**COMMENT-RESPONSE DOCUMENT (CRD)
TO NOTICE OF PROPOSED AMENDMENT (NPA) 2011-03**

for amending Decision 2003/2/RM of the Executive Director of the European Aviation Safety Agency of 17 October 2003 on certification specifications, including airworthiness codes and acceptable means of compliance, for large aeroplanes ('CS-25')

'Large Aeroplane Certification Specifications in Supercooled Large Drop, Mixed phase, and Ice Crystal Icing Conditions'

Figure 1 –Appendix O, Freezing Drizzle, Liquid Water Content

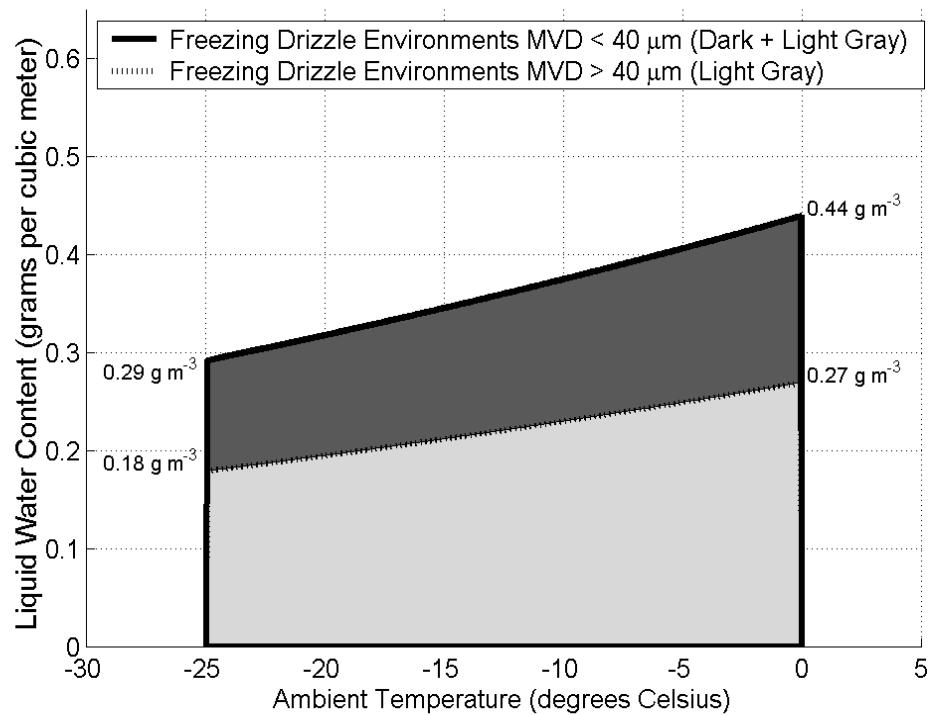
The above plot, excerpted from figure 11 pg 32 of Jeck, DTO/FAA/AR-09/10 shows a clear reduction in available LWC at temperatures below -10 deg C. The proposed appendix should be modified to be consistent with meteorological observations. This was missed by the FAA and industry during the comment period for NPRM 10-10.

We assume you refer to figure 1, page 64. This figure is identical to the one provided by the IPHWG report. We rely on the expertise of this group concerning the pertinence of the corner points. There was no recorded disagreement or divergence within the Group on this aspect.

Figure 2 – Appendix O, Freezing Drizzle, Drop Diameter Distribution

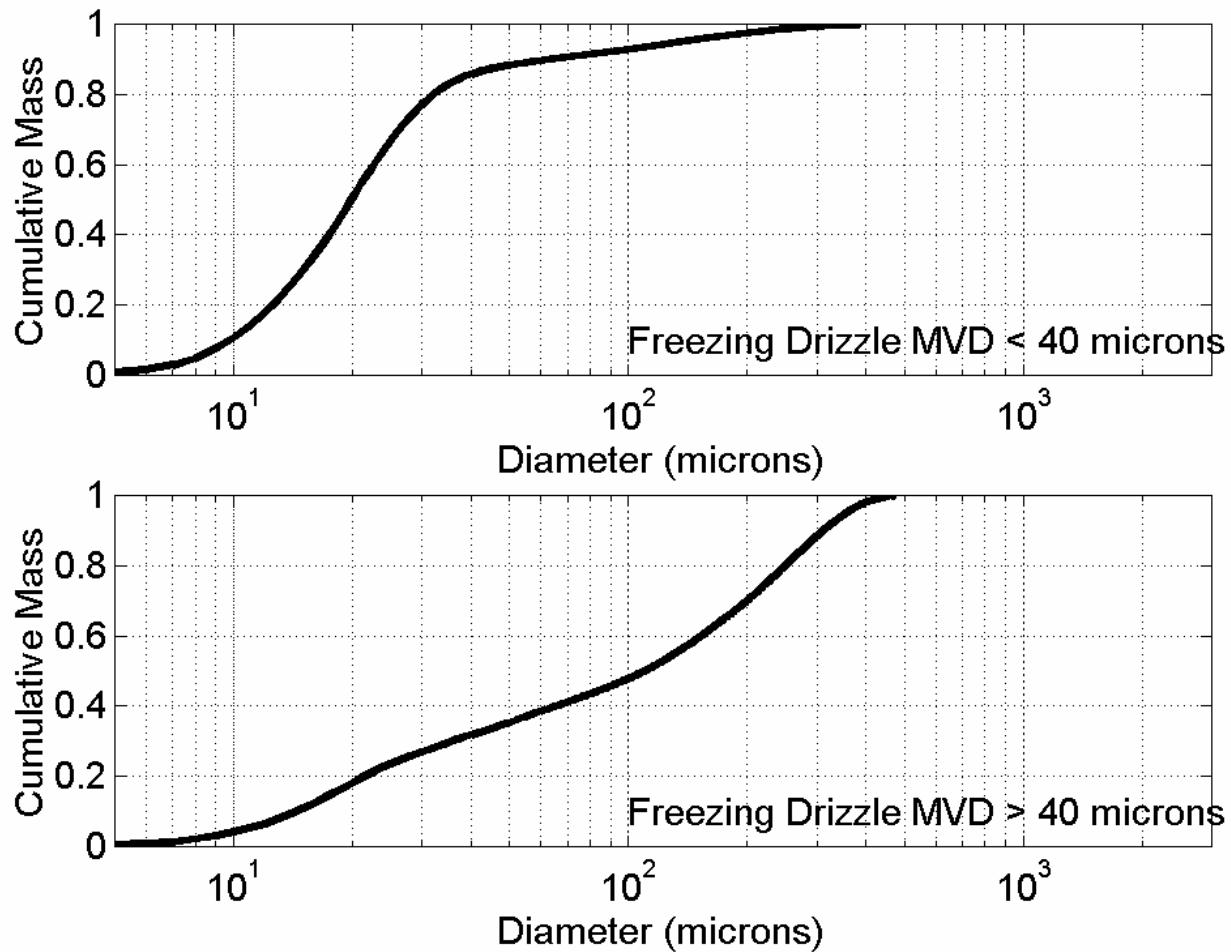
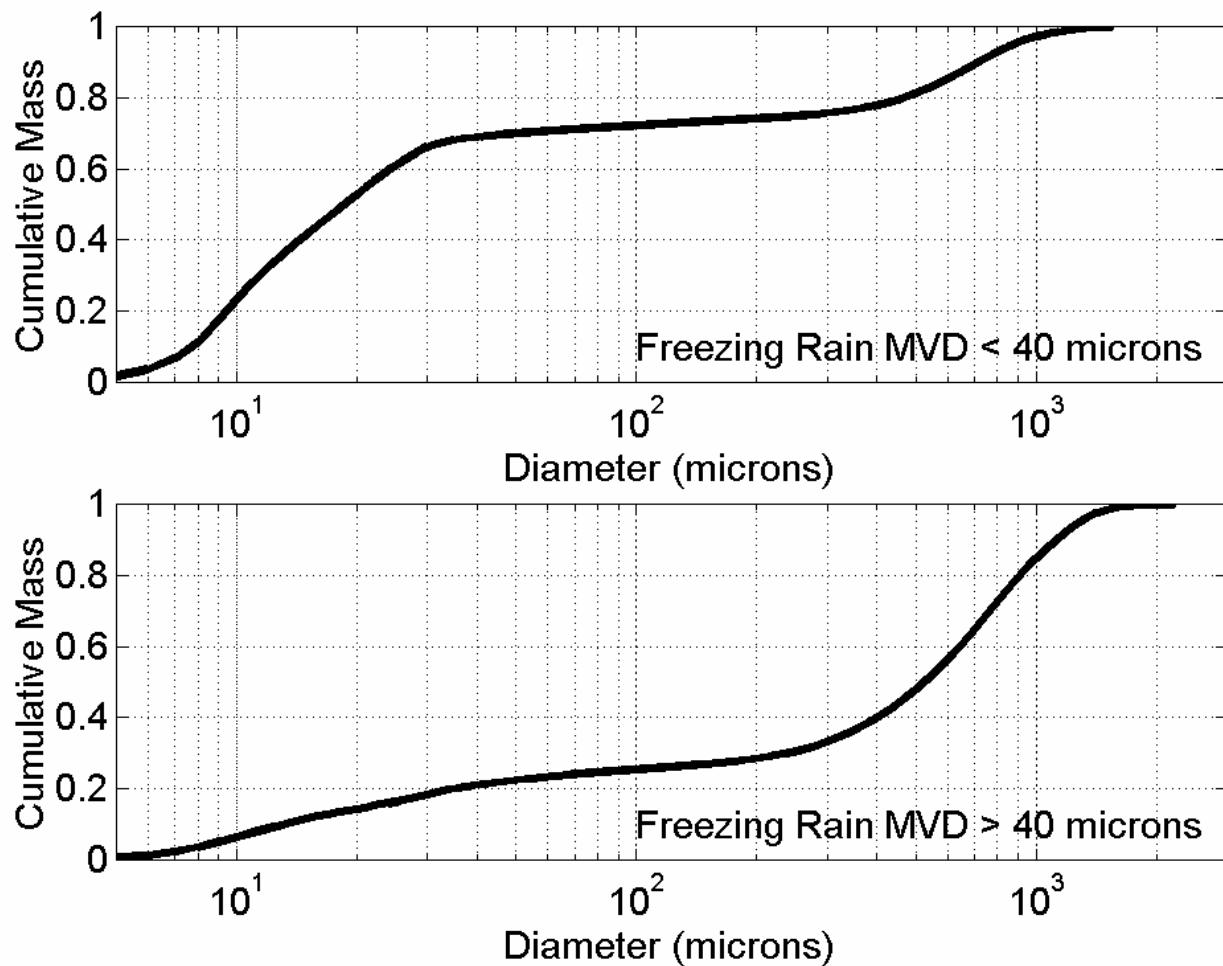
To aid the reader to understand Figures 2 and 5 of Appendix O to CS 25 Embraer proposes to add a definition of Cumulative Mass:

Figure 7 – Appendix O, Horizontal Extent, Freezing Drizzle and Freezing Rain

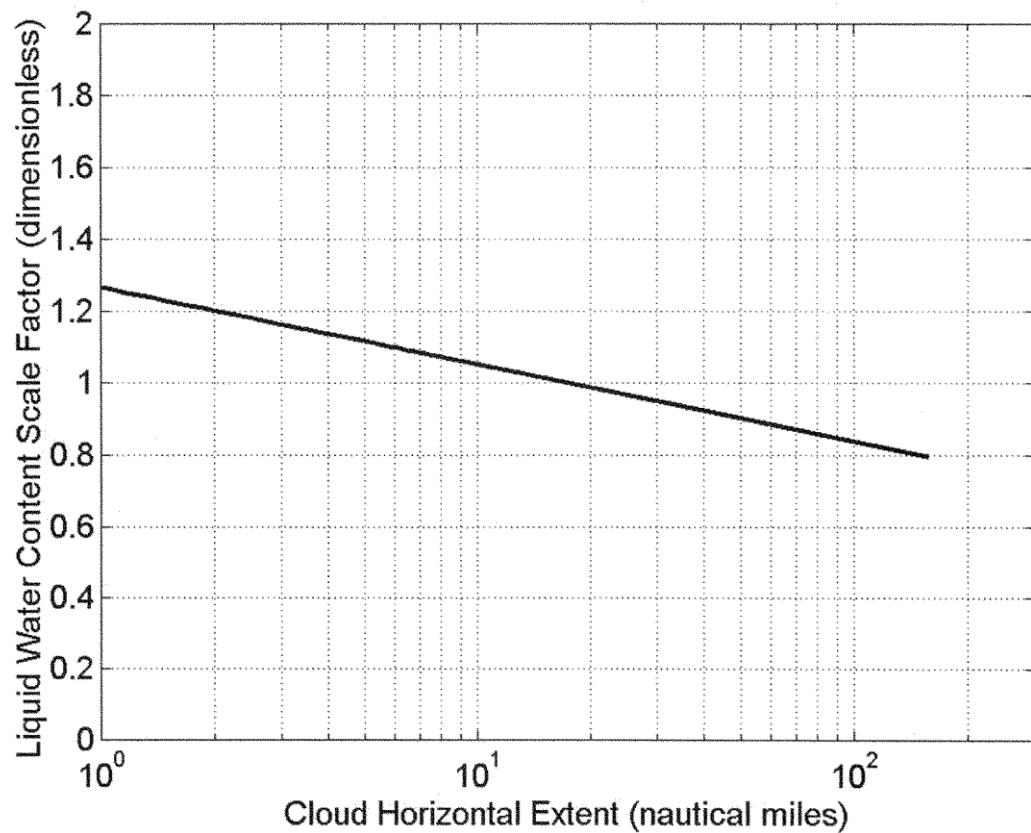
Note: Figure 7 of Appendix O Part I ("Horizontal Extent") is slightly different compared to the one published in the IPHWG report. FAA published an updated curve in their NPRM based on information from the specialist (Environment Canada) author of the curve provided to the IPHWG. We use also this new curve in our proposal.

Figure 1 – Convective cloud ice crystal envelope

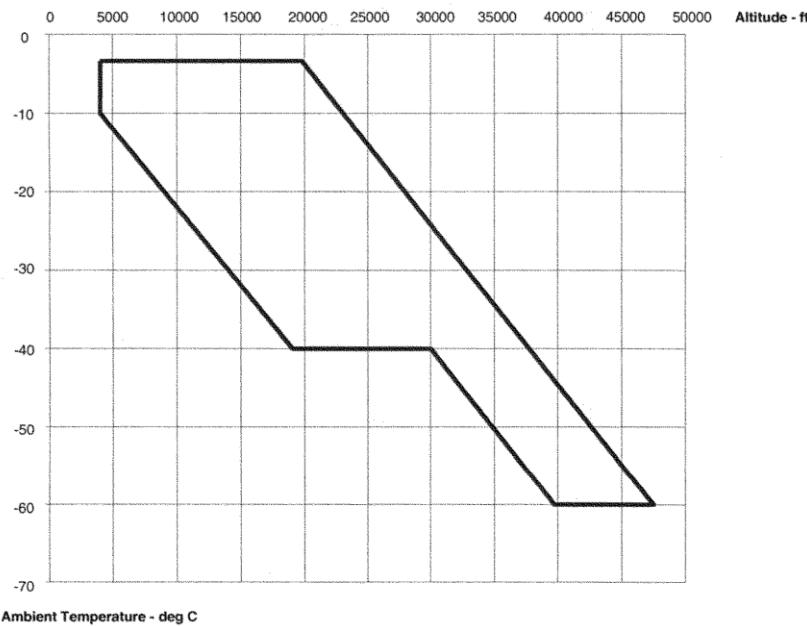
comment	<p>67 comment by: <i>Thales Avionics</i></p> <p>The observation of events outside of the envelope in Appendix P figure 1 (particularly at SAT=-70°C, Altitude=45,000ft) make the extension of the envelope to these points mandatory. However, extending the envelope beyond SAT = -70°C should not be considered as not grounded by any observation and</p>

"The proposed Appendix P is identical to the FAA proposed Appendix D to Part 33, which originated from the ARAC recommendations. Based on EASA knowledge of service experiences with Pitot probes, the associated convective cloud ice crystal icing envelope (Figure 1 of Appendix P) would cover an important portion but not all of the occurrences. Indeed, EASA is aware of incidents of temporary erroneous airspeed indication which happened at high altitude with static air temperature (SAT) below the current proposed Appendix P limit of -60°C. One of these events happened at (SAT=-70°C, Altitude=45,000ft). Other events occurred at SAT above -60°C but at altitudes outside the proposed Appendix P, figure 1.

For this reason, EASA is envisaging an extension of Appendix P, figure 1 envelope to encompass all the known occurrences, with a minimum temperature of -75°C. This extension should also include the current AMC 25.1419 Ice crystal conditions envelopes. Any comments on this proposal are welcome."

The observation of events outside of the envelope in Appendix P figure 1 (particularly at SAT=-70°C, Altitude=45,000ft) make the extension of the envelope to these points mandatory. However, extending the envelope beyond SAT = -70°C should not be considered as not grounded by any observation and because of its unreasonable impact on probe designs, on their installation and of the resulting economic impact.
